The General Manager  
Port Stephens Council  
council@portstephens.nsw.gov.au

## Objection: DA 2020-242, 62 unit apartment building 118A Soldiers Point Rd

EAST ELEVATION (CARPARK) 1:300

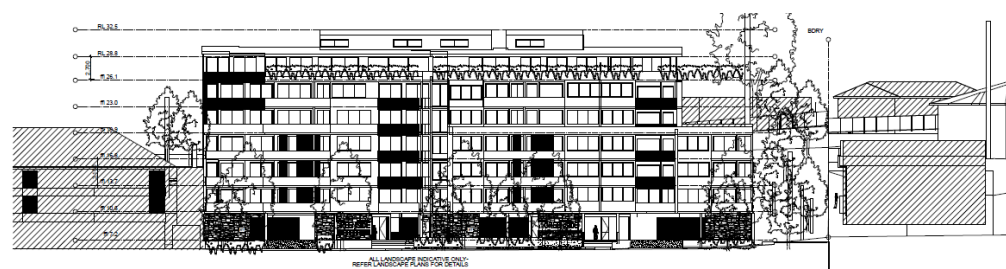
The development site is unusual in that it has no street frontage, but its frontage to the Bowling Club car park is equivalent. TRRA submits that a 7 level building is not compatible in scale with first two blocks of existing Greenside complex – which are only 3 level (car park + 2) + hip roof). This incompatibility is clear from the elevation and image shown in the Architectural Plans (Appendix 2) and reproduced below.
